IN THE UNITED STATES PATENT AND TRADEMARK OFFICE

Reissue Application of: Nicholas J. Bonge, Jr.)
Filed: February 14, 2001)
Title: ULTRASONIC TRANSCEIVER AND)
REMOTE CONTROLLED DEVICES FOR)
PETS)

RULE 121(b) PRELIMINARY AMENDMENT

FIG. 5

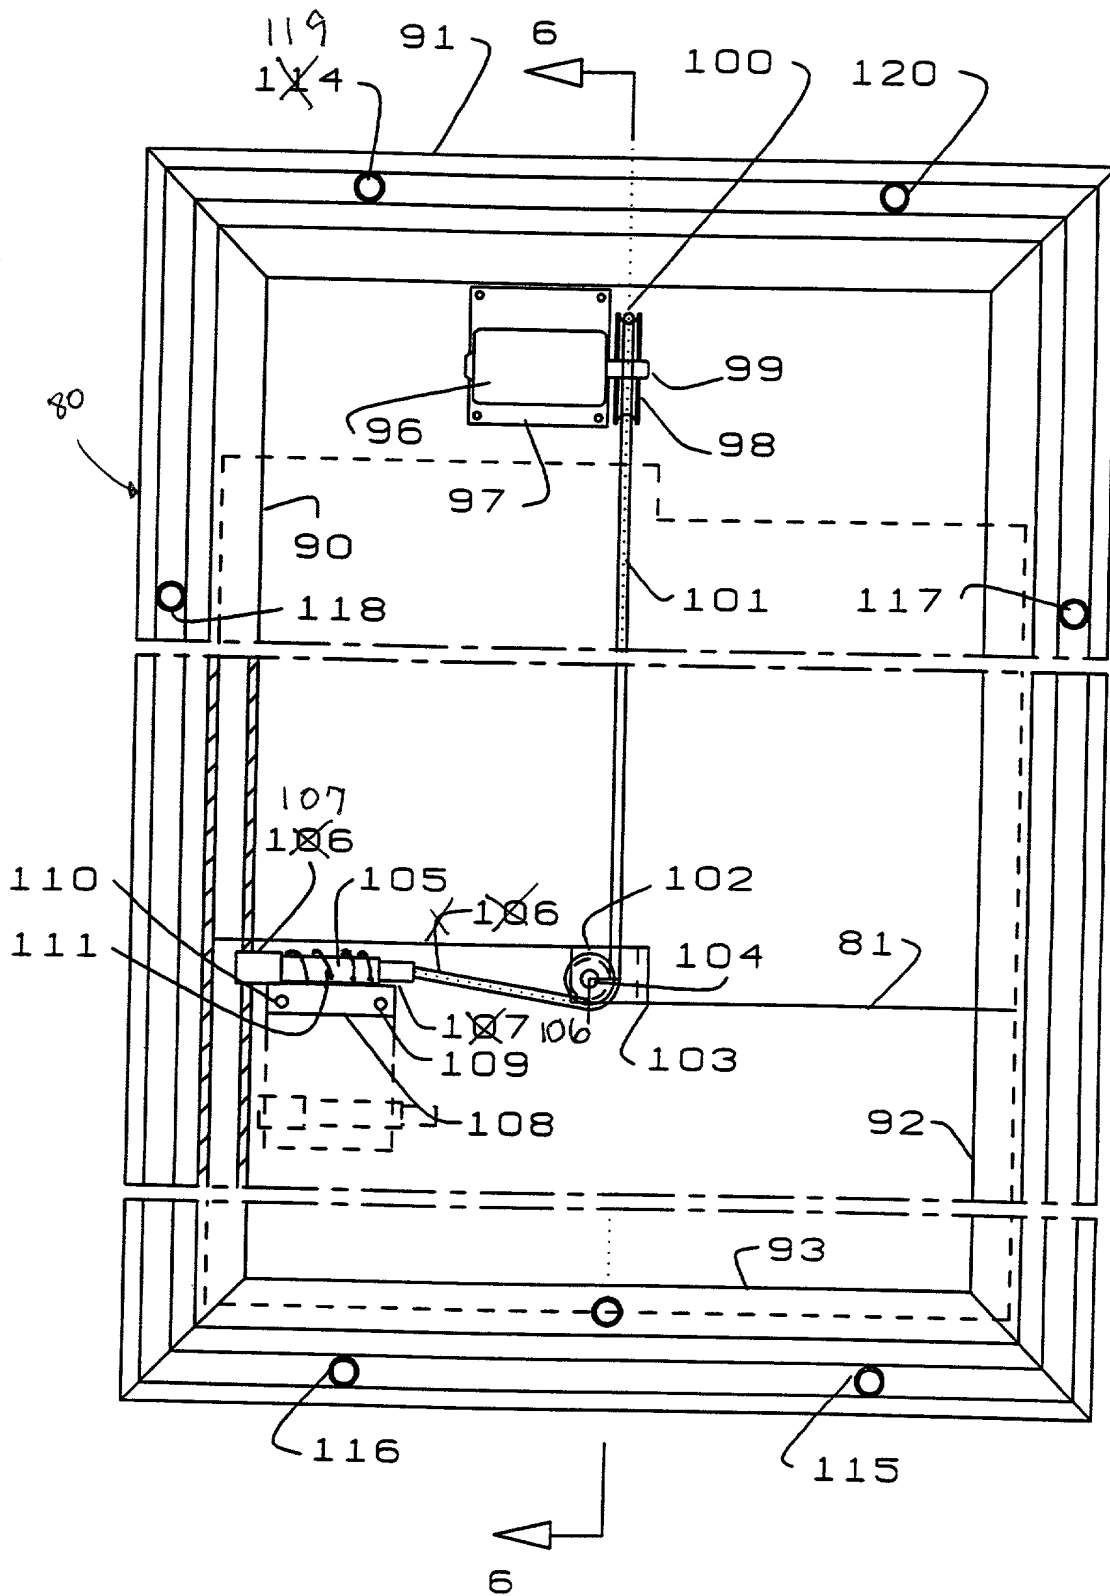
Please accepted amended Figs. 4-6 as submitted herewith.

The pet door of the present invention further includes an electric motor 96 that is fixed to top frame member 91 with mounting bracket 97. Motor shaft 99 extends outwardly from motor 96, and spool 98 is rigidly fixed to motor shaft 99 with set screw 100 (See FIG. 5) so that spool 98 rotates with motor shaft 99 during operation. To raise and lower

Pin bracket 108 is rigidly fixed to movable panel 81 by screws 109 and 110, and locking pin 105 is slidably mounted to bracket 108, as best seen in FIG. 5. This allows locking pin 105 to move in translation into locking pin hole 107 which is formed in left frame member 90. A compression spring 111 is fitted around locking pin 105 and biases locking pin 105 into locking pin hole 107, thus, preventing the movable panel from being moved out of door opening 83 while there is slack in cable 101. With this configuration, it is not possible for an intruder to manually lift movable panel 81.

Front and rear plates 112 and 114, FIG. 6, respectively interfit with grooves 127 and 113 and act to enclose the upper portion of the assembly. Door mounting holes 115-120, FIG. 5, are provided to mount the assembly to a household door or wall.
